DESCRIPTIVE REPORT

Type of Survey	HYDROGRAPHIC	
Field No.	RA-10-17-04	
Registry No.	H-11366	
	LOCALITY	
State	Alaska	
General Locality	Eastern Prince Willia	m Sound
Sublocality	Vicinity of Bligh Reef	
	2004	
CDI	CHIEF OF PARTY R John W. Humphrey, NOA	\A
1	LIBRARY & ARCHIVES	
DATE

Descriptive Report to Accompany Hydrographic Survey H11366

Project OPR-P132-RA-04
Eastern Prince William Sound, AK
Scale 1:10,000
August – September 2004

Figure 1. H11366 Survey Limits and Junctions

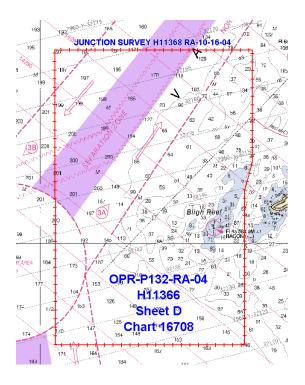
The following contemporary survey junctions with H11366 (see Figure 1):

A cursory junction comparison between H11368 and H11366 indicates differences are generally less than one-half fathom.

Final comparisons will be made at the Pacific Hydrographic Branch (PHB) after the application of smooth tides.⁵

⁵ Concur with clarification. Junction comparisons were made with H11368 during office processing. Sounding and depth curves are in good agreement and a "Joins" note has been added to the smooth sheets.
